402 LEE STREET
DECATUR, ALABAMA 35601
July 13, 2023

Architectural Review Board

CoA #2: 626 Grant (Pritzel)

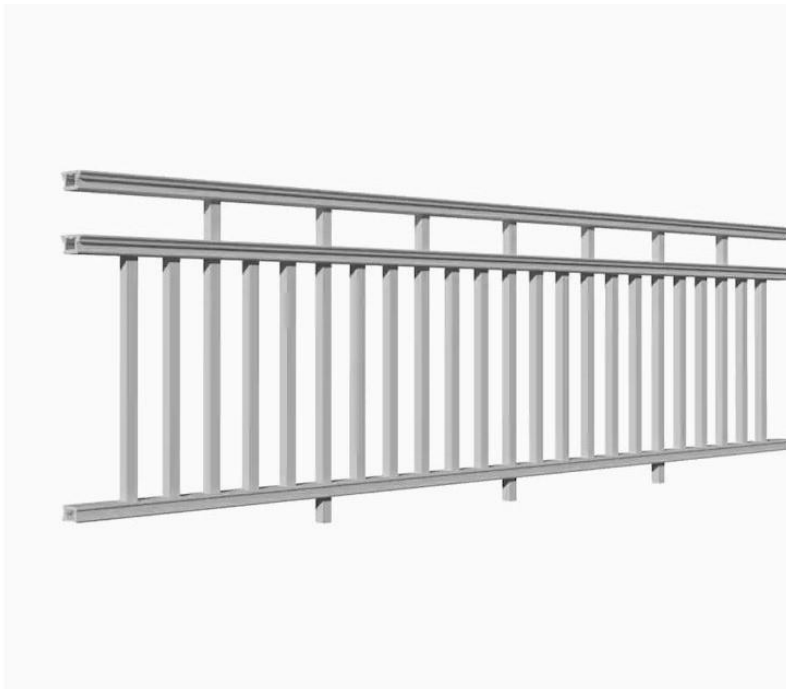
Staff Findings: Mr. Pritzel had new siding ordered to match the exact siding that was on the house. The commission has required that siding replacement be on an as-needed basis with the district, not wholesale elevation replacement. (Most recently as-need siding replacements have occurred at 101 Walnut and 1038 Jackson).

Some of the porch columns at the residence at the time work started were fiberglass, so the porch had a mixture of both historic wood and synthetic. The commission has approved synthetic columns to replace severely damaged wood columns in the past, most recently at 714 Line). Columns where just the bases were damaged have traditionally had new bases built and inserted.

Staff has no data on the proposed new east side second floor porch supports, or the proposed railing.

The front porch historic railing was at the standard 28" height. The new railing is 34.5". Owner has stated he wants a taller railing since the historic railing didn't meet code. The commission has approved a railing with extenders on it (see photo below) as an acceptable alternative for new standard height railings if Mr. Pritzel would like a railing at that height. Mr. Pritzel proposes adding an additional horizontal strip to simulate the full height railing, since he has already constructed a new guard railing.

Staff reached out to the building department for clarification of guard railing heights. A railing at the original 28" height is allowed because that height was grandfathered in. Any new guard railing to meet code must be at 36" high (new stair railing heights can be between 34" and 38"). Current new guard railing height as constructed is 34.5"
